BID PACKAGE 01 – ADDENDUM 02

Date: December 10, 2019

Re: Wilma P Mankiller Health Center Expansion

Bid Package 01- Addendum 02 – Wilma P. Mankiller Health Center Expansion

SHEET NUMBER: S1.21

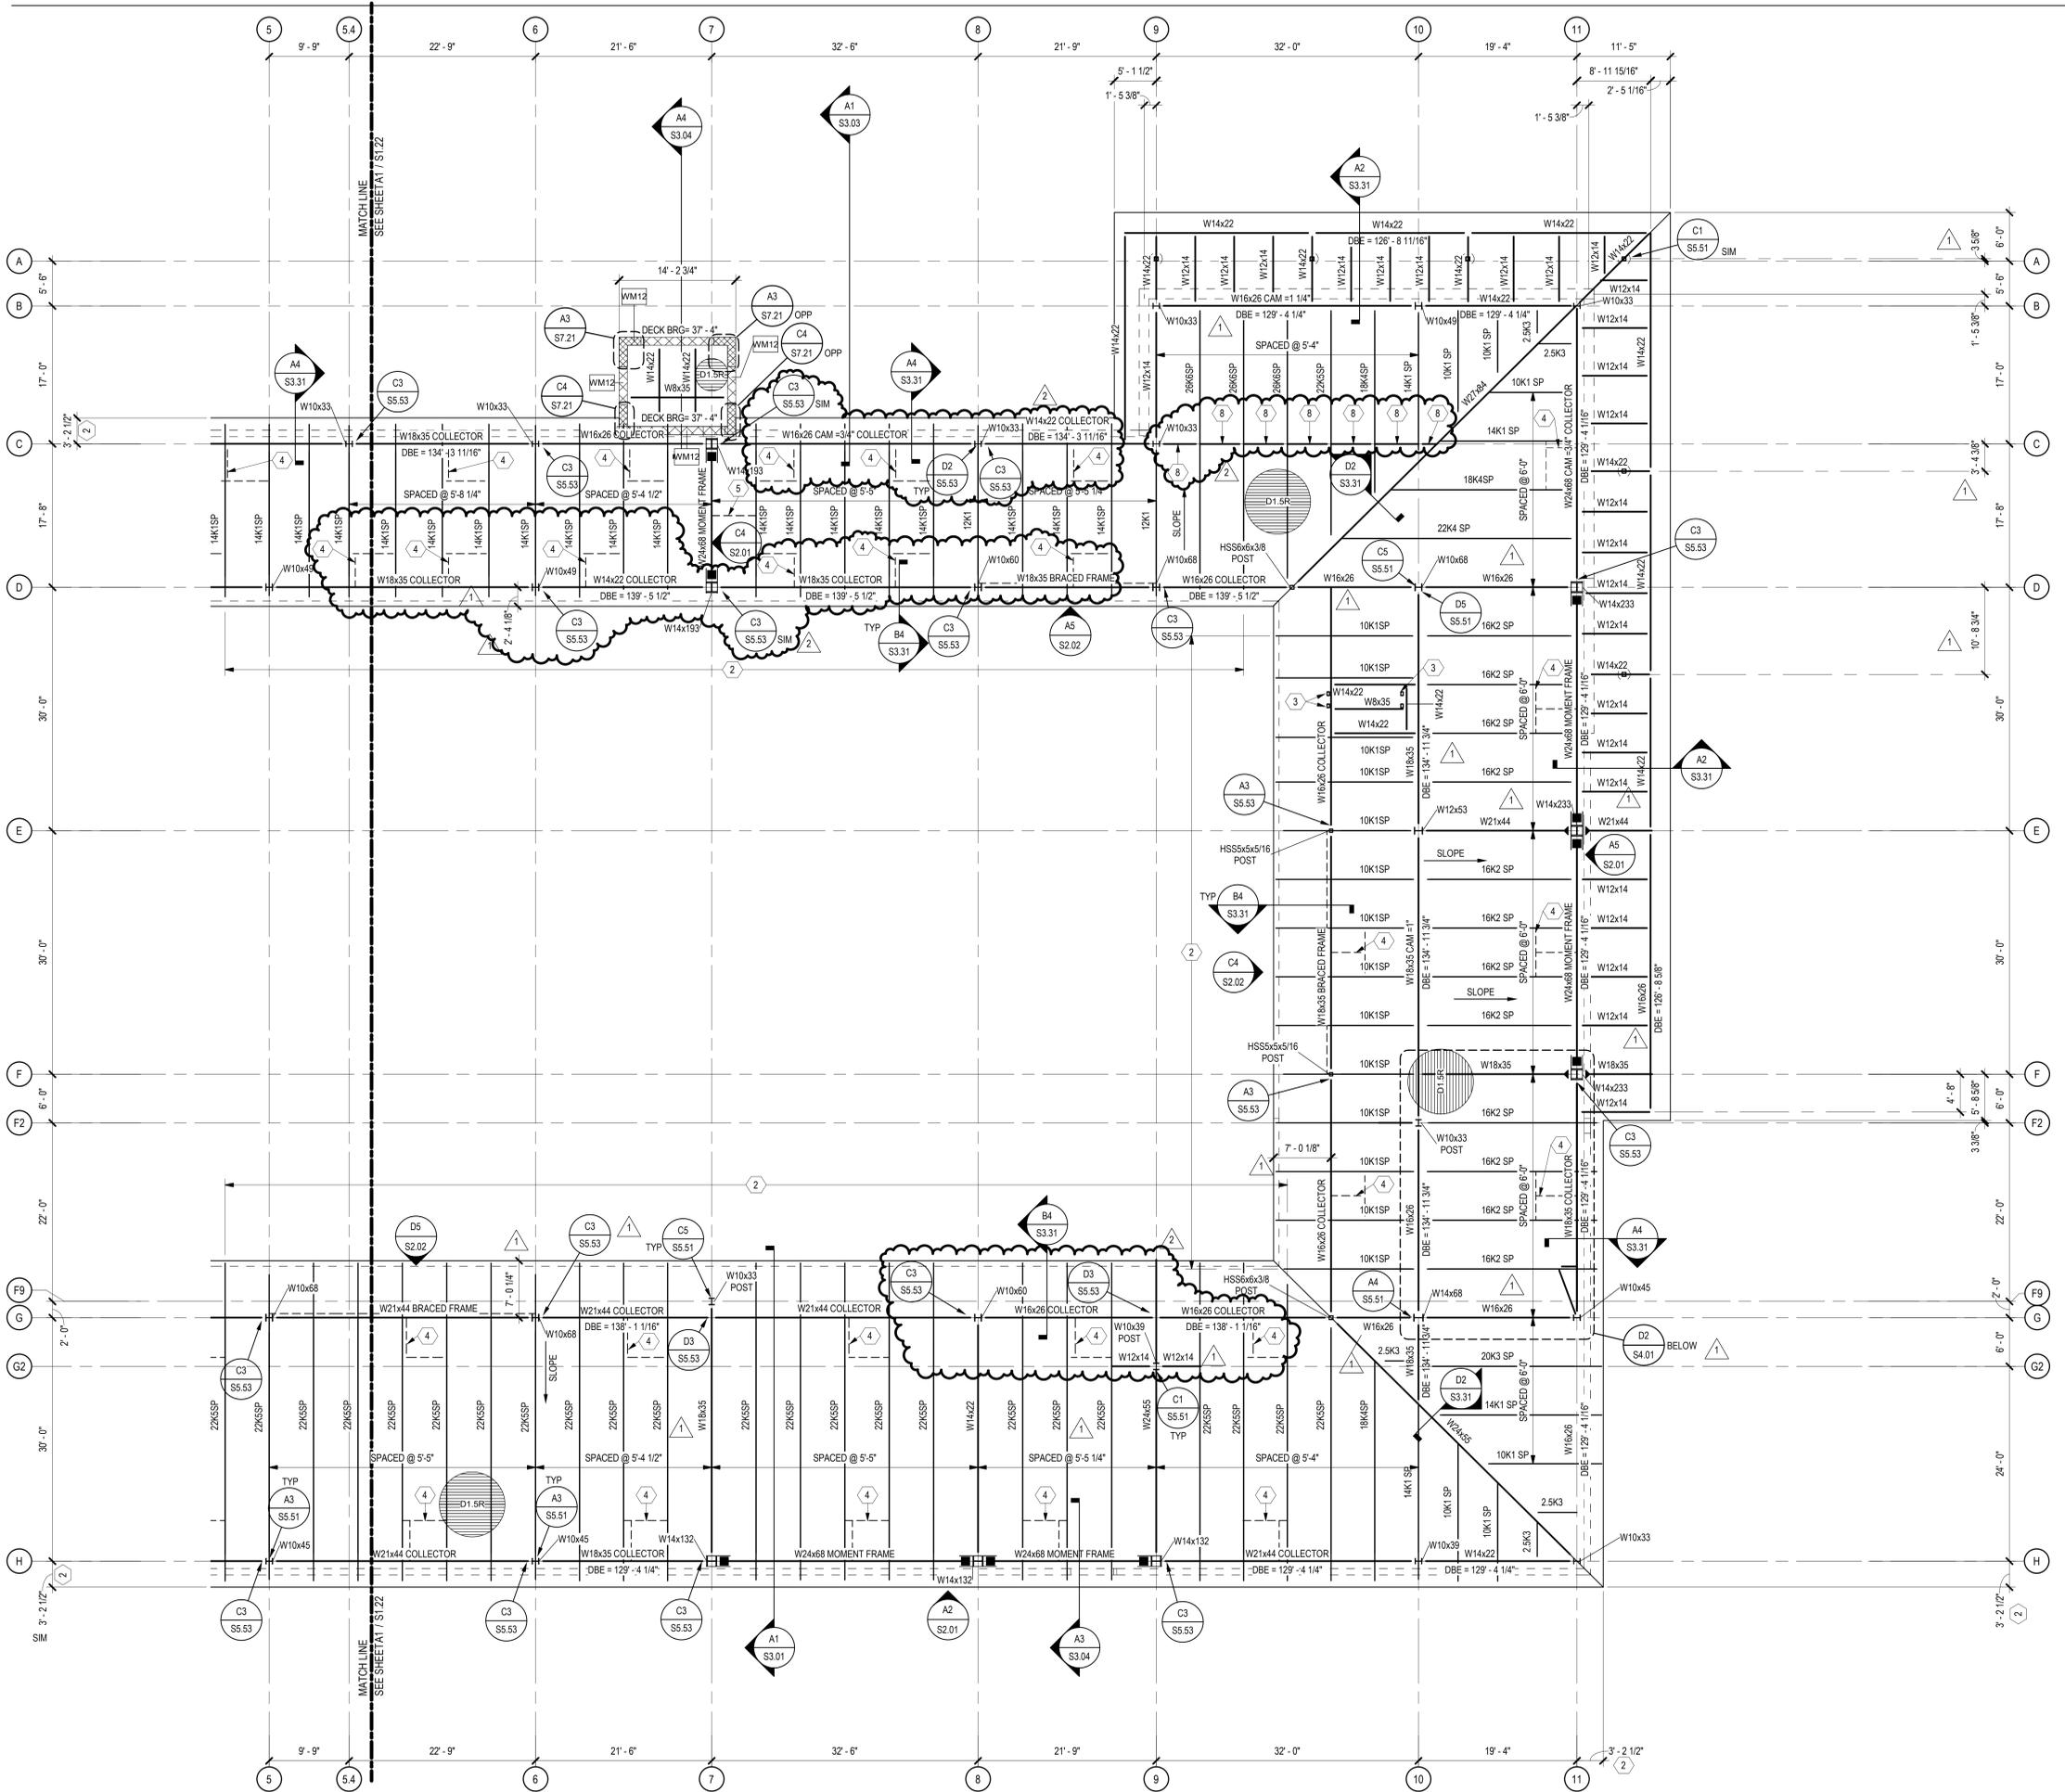
<u>Sheet</u>	<u>Description</u>
S1.02	Rolling door support elevation added near Grid F/1.
S1.12	Rolling door support elevation added near Grid F/1.
S1.13	Stair landing framing adjusted to meet architectural requirements; near Grid E/2. Dimensions added.
S1.21	Sheet keynote 8 added and located on plan.
S1.21	Connection details revised along Grid G, D, and C.
S1.21	Beam sizes near Grid G/8 revised.
S1.21	Bottom flange braces added to beams along Grid G, D and C labeled as "Collector".
S1.22	Sheet keynote 8 added and located on plan.
S1.22	Connection details revised along Grid H, G, and D.
S1.22	Beam size near Grid H/3 revised.
S1.22	Bottom flange braces added to beams along Grid H, G and D labeled as "Collector".
S2.02	Elevations B3 and D4 revised
S3.11	Section D2 revised.
S3.12	Section A3, B3, and D4 added.
S4.01	Plans A3, D2, and D4 revised.
S5.54	Details A2 and B4 added.
S7.41	Detail C2 revised.

SHEET NUMBER:
S5.54
STEEL DETAILS

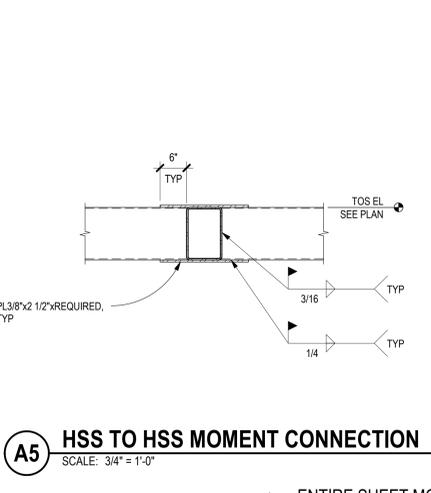
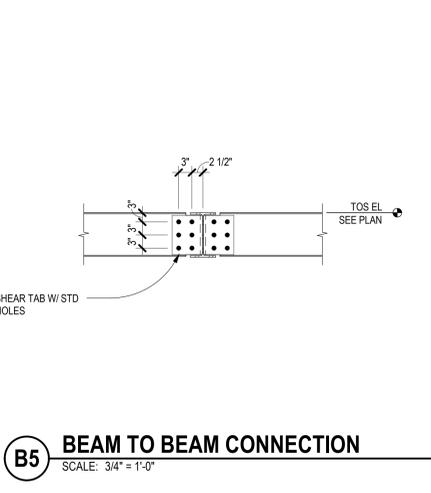
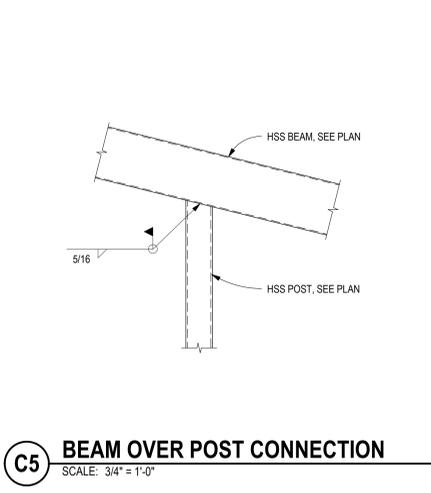
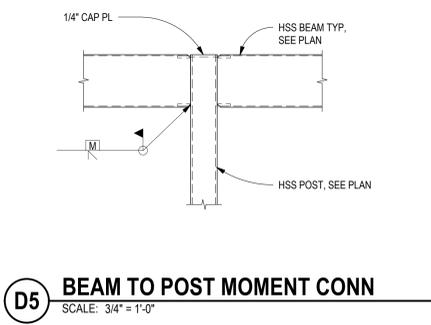
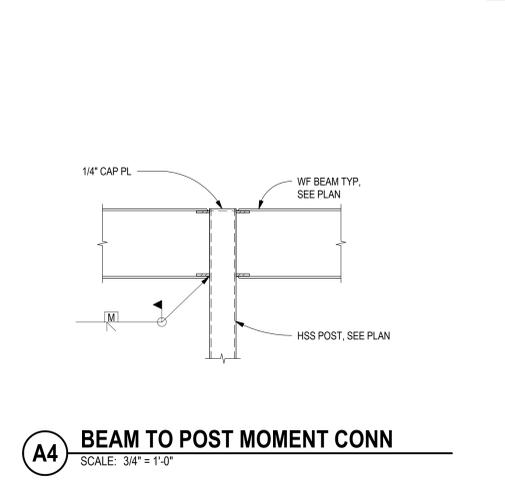
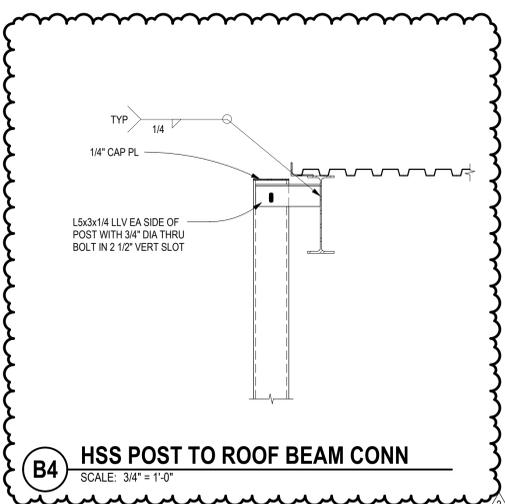
ENTIRE SHEET MODIFIED
